ADDENDUM NO. 1
FOR
COMMUNITY SAFE ROOMS FOR CAVE SPRINGS, EGYPT,
MOUNTAINBORO AND NEW UNION (AURORA) COMMUNITIES
ETOWAH COUNTY, AL

NOVEMBER 13, 2017

SUBJECT: Plans, Specifications, and Contract Documents are hereby amended, modified, and changed as follows:

**Plan Sheet 4
ADDENDUM NO. 1**

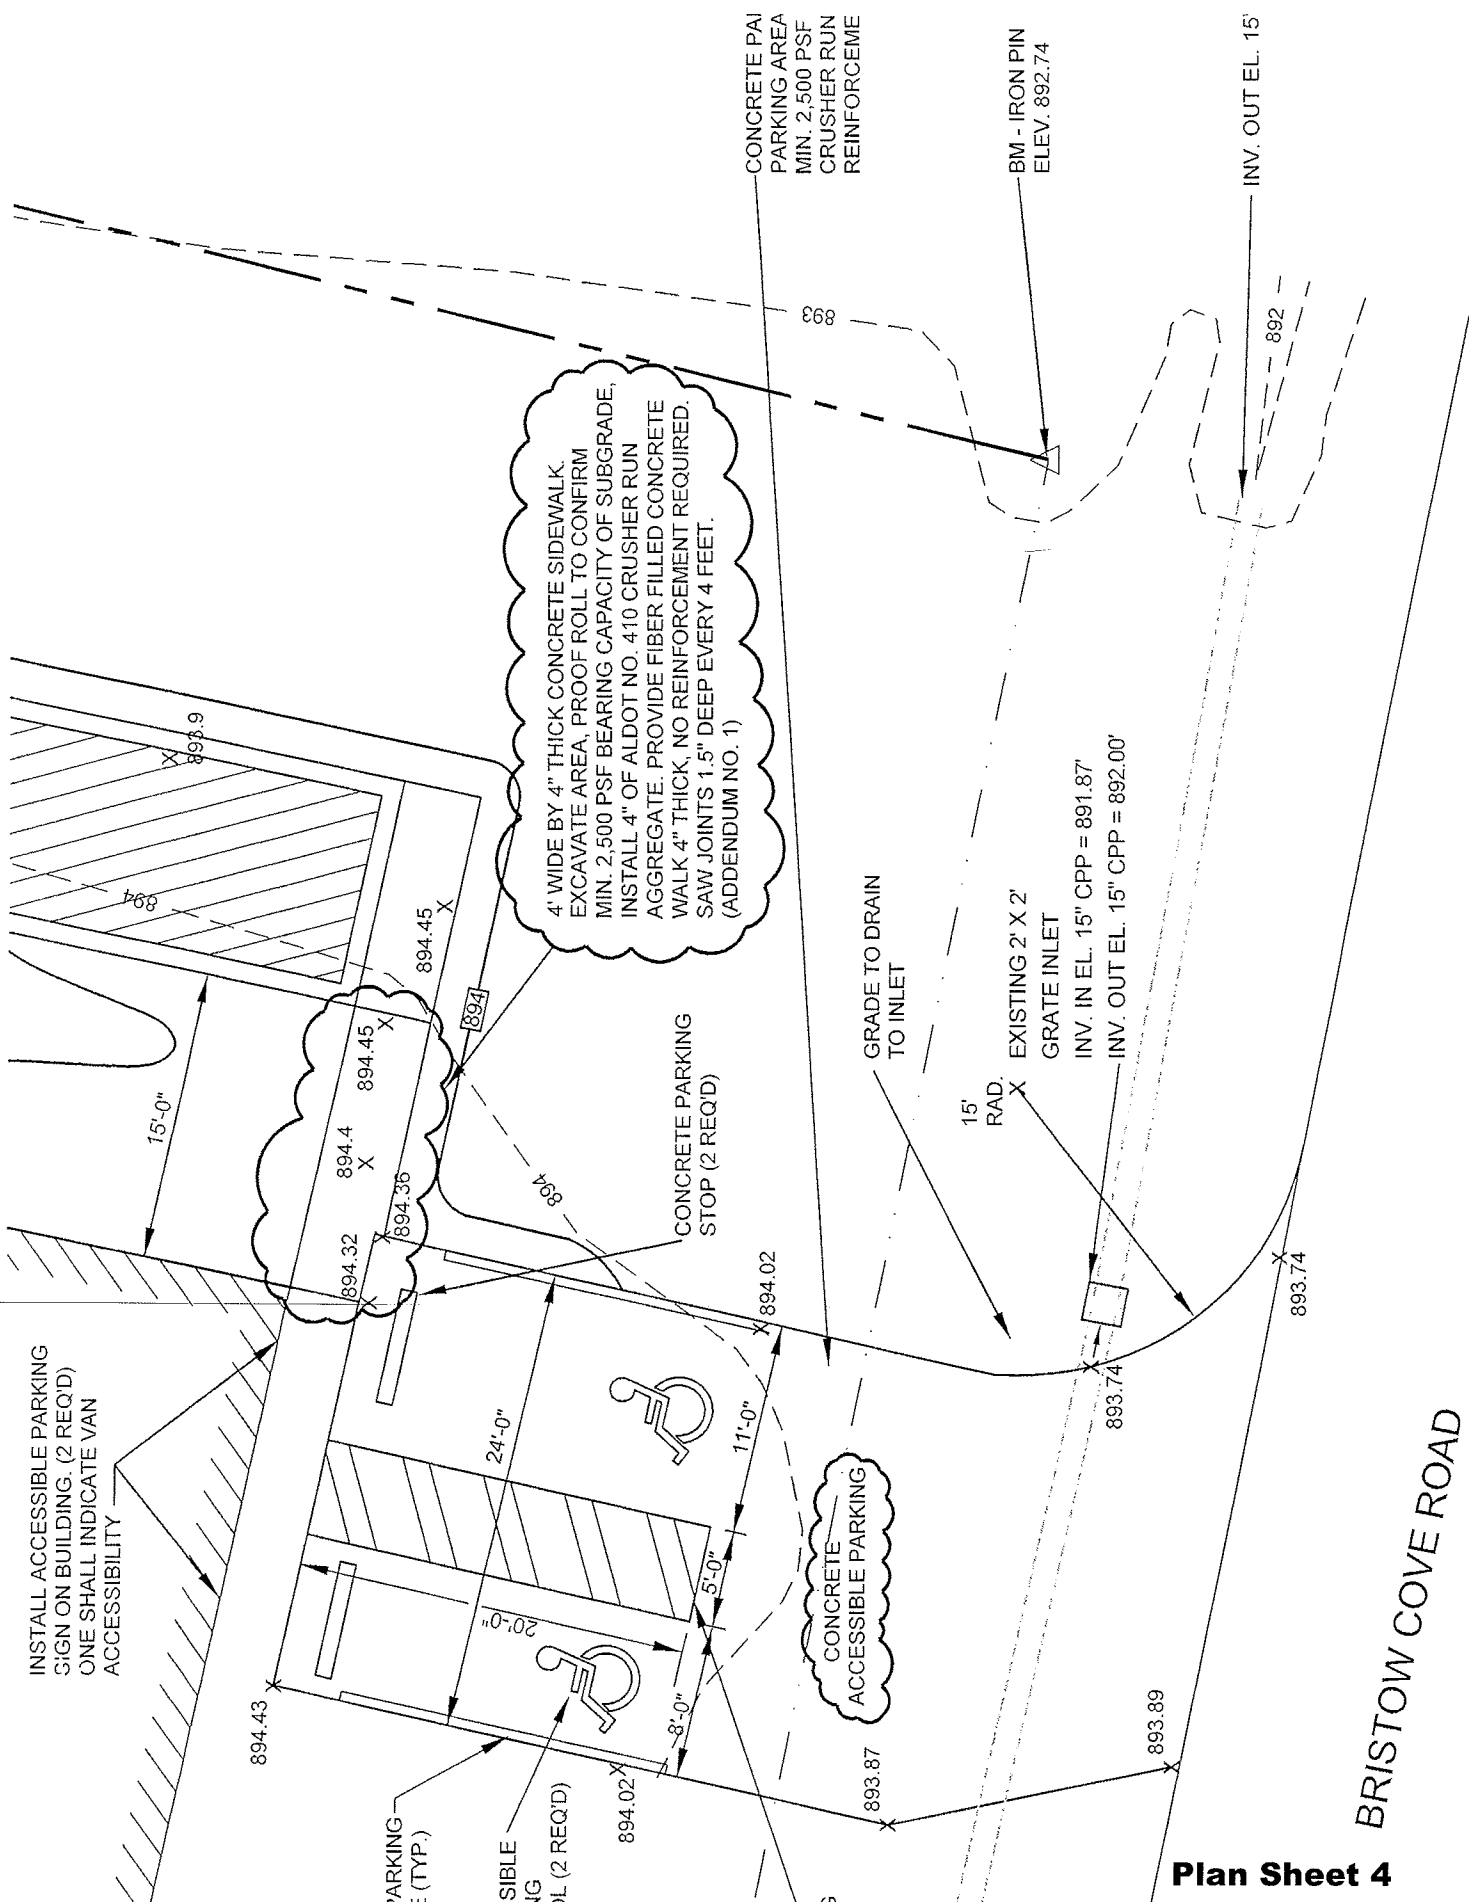
- II. Reference Plan Sheet No. 4
 - A. The attached drawing on page ADM1-3 hereby modifies the plan to include a sidewalk at the New Union safe room and clarifies that the accessible parkway area is concrete.
 - B. The Contractor is to provide a complete installation at the New Union site. Note No. 1 is hereby changed to read as follows:
 1. Contractor to provide and install safe room and related appurtenances.
